RE: UTILITY IMPROVEMENTS - PHASE II

ELKTON. SOUTH DAKOTA

SPN #15693

ADDENDUM NUMBER 1

Section C-410, Bid Form, Page 10:

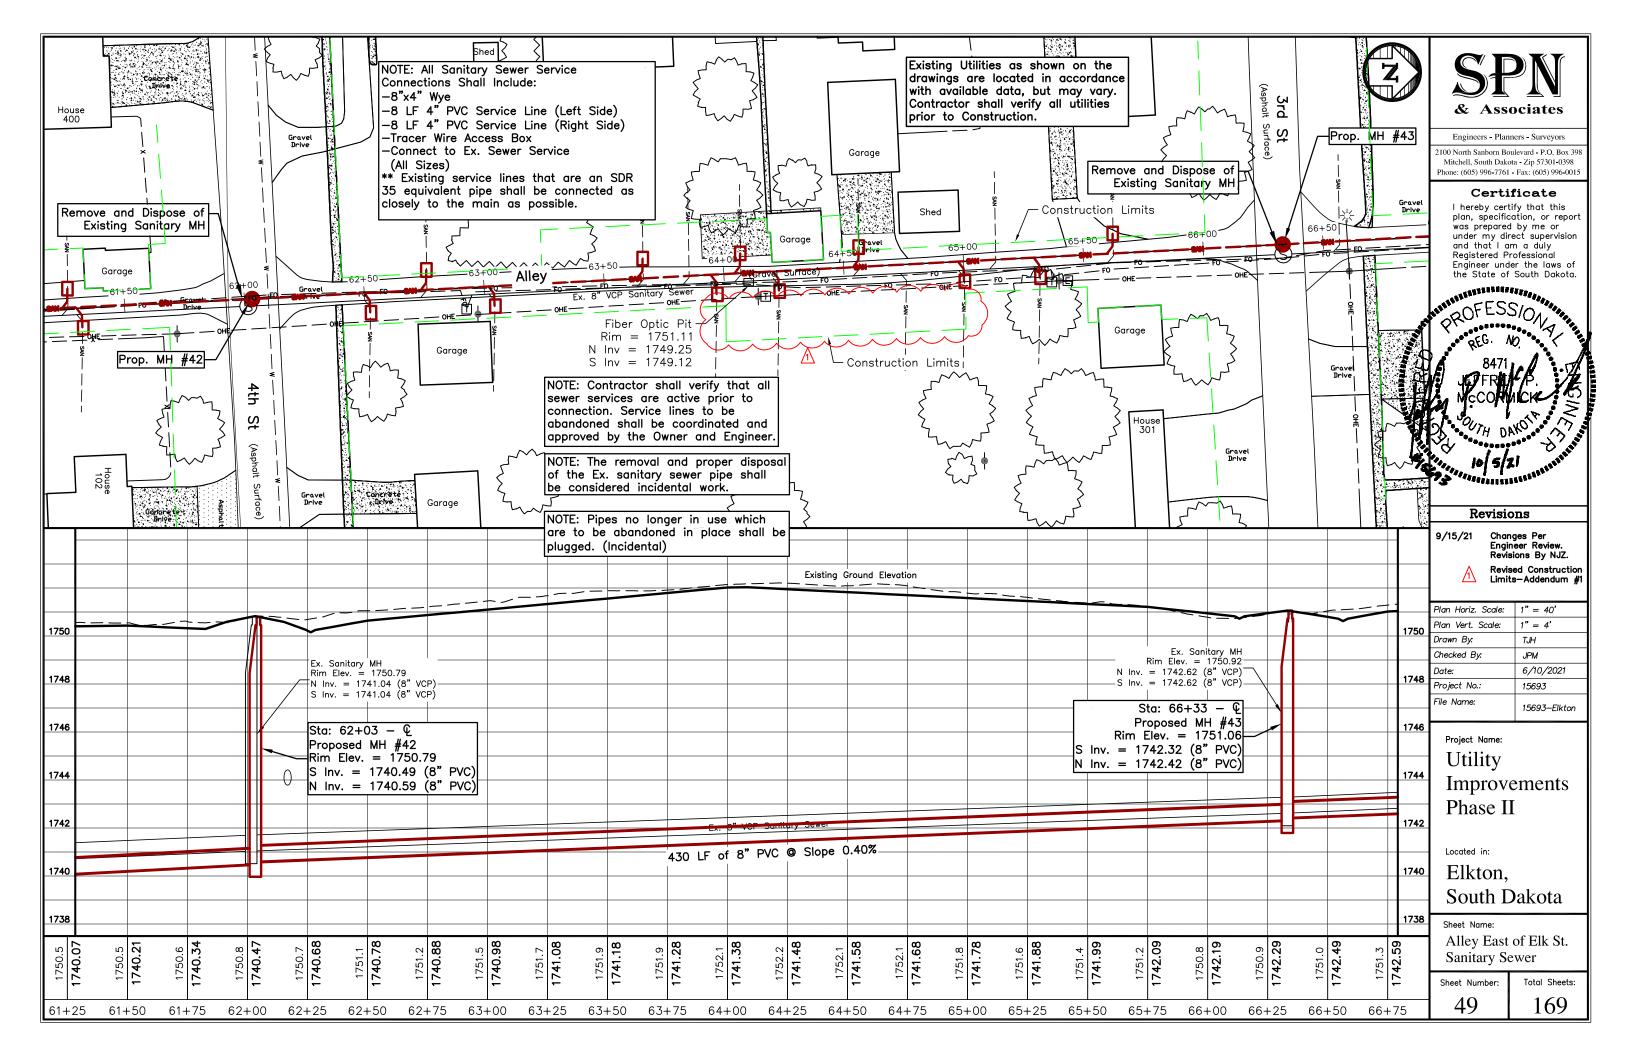
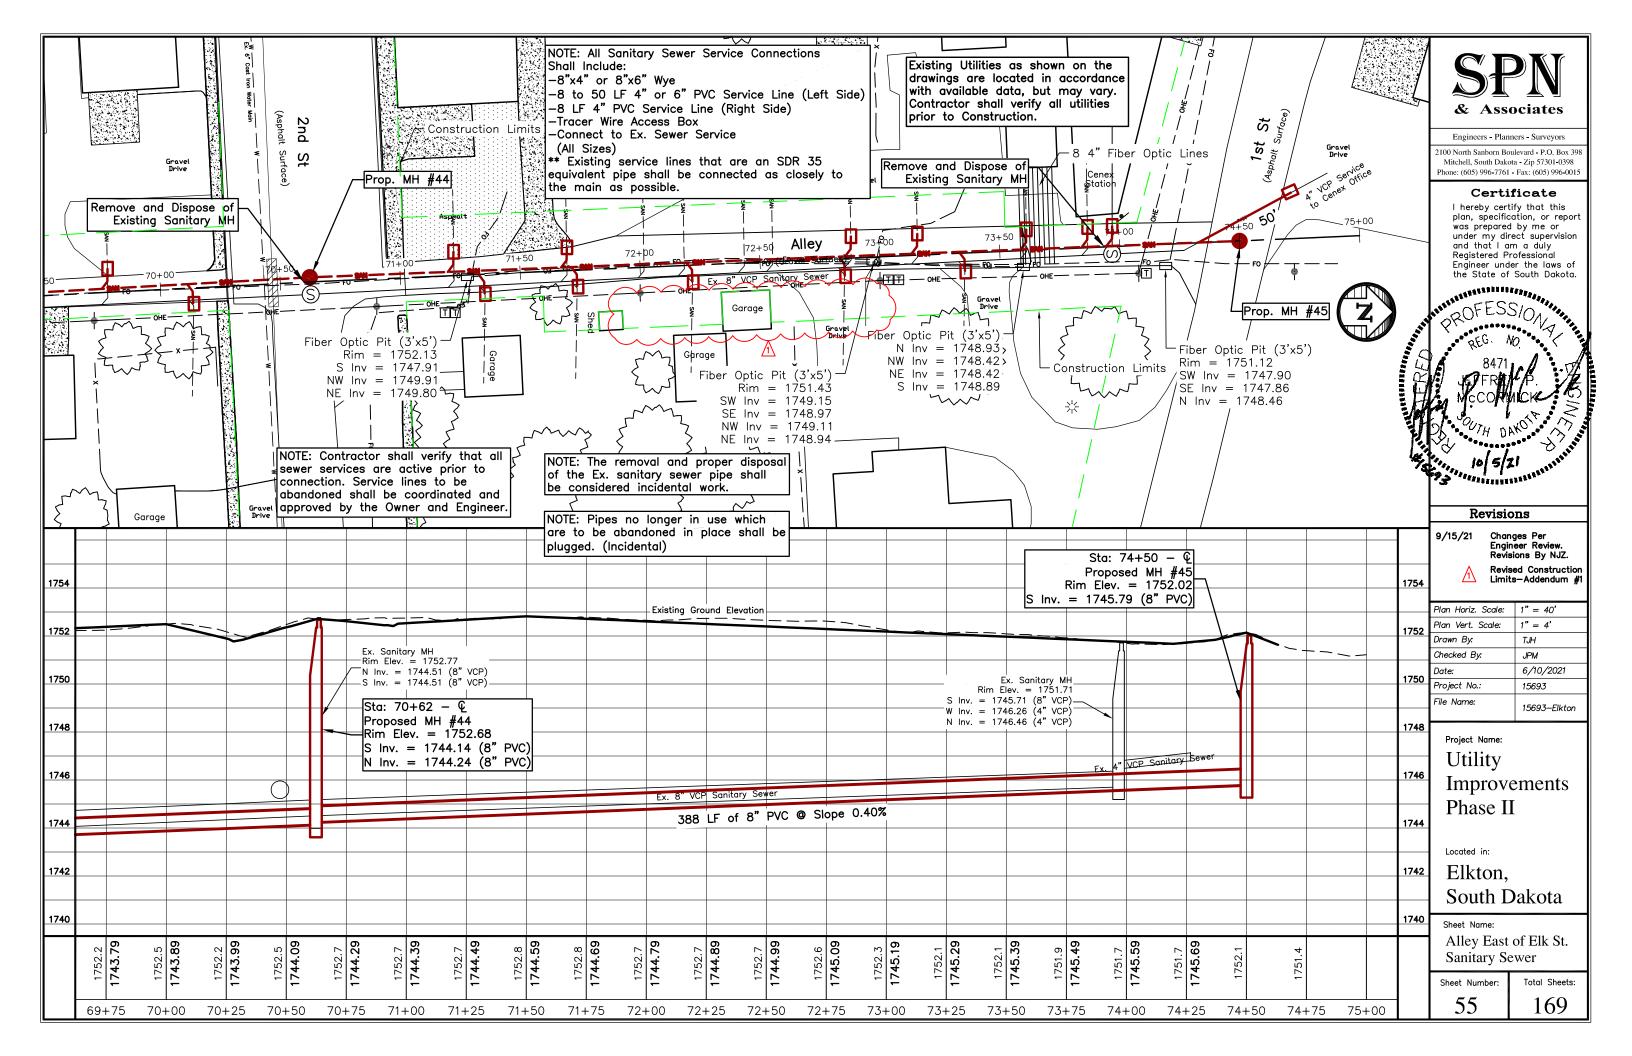
There are 3 hours for exploratory digging for the project. Bid Item #104 was added to the Bid Form. A revised Page 10 of the Bid Form is attached.
